# UNITED STATES PATENT AND TRADEMARK OFFICE

APPLICATION NO.	FILING DATE	FIRST NAMED INVENTOR	ATTORNEY DOCKET NO.	CONFIRMATION NO.
10/646,094	08/22/2003	Richard L. Dubay	D398.12-0001	8387
164	7590	08/22/2007		
KINNEY & LANGE, P.A. THE KINNEY & LANGE BUILDING 312 SOUTH THIRD STREET MINNEAPOLIS, MN 55415-1002			EXAMINER JOHNSON, MATTHEW A	
			ART UNIT 3682	PAPER NUMBER
			MAIL DATE 08/22/2007	DELIVERY MODE PAPER

<b>Office Action Summary</b>	<b>Application No.</b> 10/646,094	<b>Applicant(s)</b> DUBAY, RICHARD L.	
	<b>Examiner</b> Matthew Johnson	<b>Art Unit</b> 3682

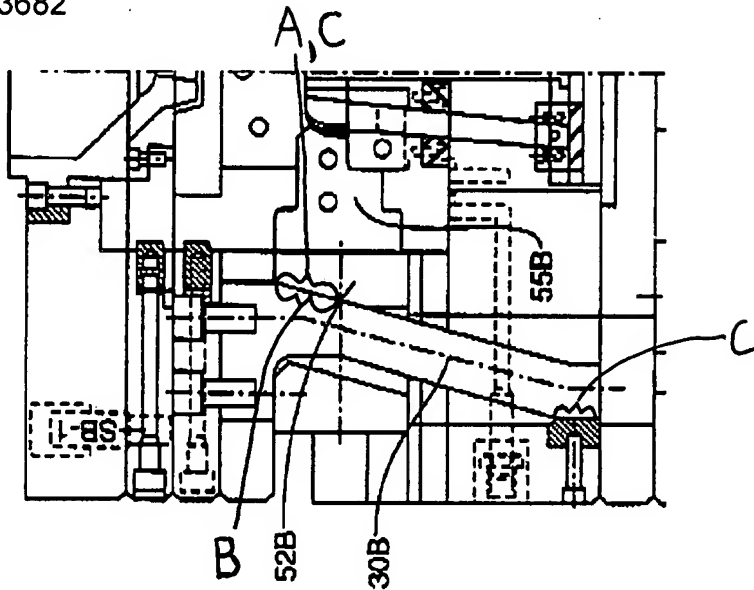
- Cam lever (30a-d) mountable to a second die block half (12) and removably insertable into the slide during a molding or casting cycle (C6 L51-54), the cam lever comprising a head (Fig. 2 mounted in plate 22) and a tail (Fig. 2 protrusion from the head) having a first cam flat surface (B, see attached figure below) extending from the head at the oblique angle for insertion into the slot; wherein the cam lever is adapted to move the

slide relative to the base through cam action (C6 L 22-28 & L47-54) and wherein the first cam flat surface of the tail flushly abuts the first slide flat surface of the slot to retain position of the slide relative to the first die block half during an injection phase of the molding or casting cycle (Fig. 5)

- Base (53a-d and plate on top of 40, see Fig. 3) adapted to be mounted (C5 L24-29) to a first die block half (14) and having first and second tracks (Fig. 3, 53a-d) comprising grooves in the base
- Slide (52a-d) having first and second rails (Fig.3) engagable with the first and second tracks of the base such that the slide is entrained within the base and movable relative to the base (C4 L10-15) to insert and remove a core pin (55a-d; Note: 55a-d can take on a variety of shapes, C3 L44-47 & C5 L44-51) from a core (50) within the molding or casting system
- Cam lever (30a-d) adapted to be connected to a second die block half (12) and removably insertable into the slide for moving the slide relative to the base through cam action (C6 L 22-28 & L47-54) and having a flat surface (C, see attached figure above) for immobilizing the slide during a molding or casting cycle;
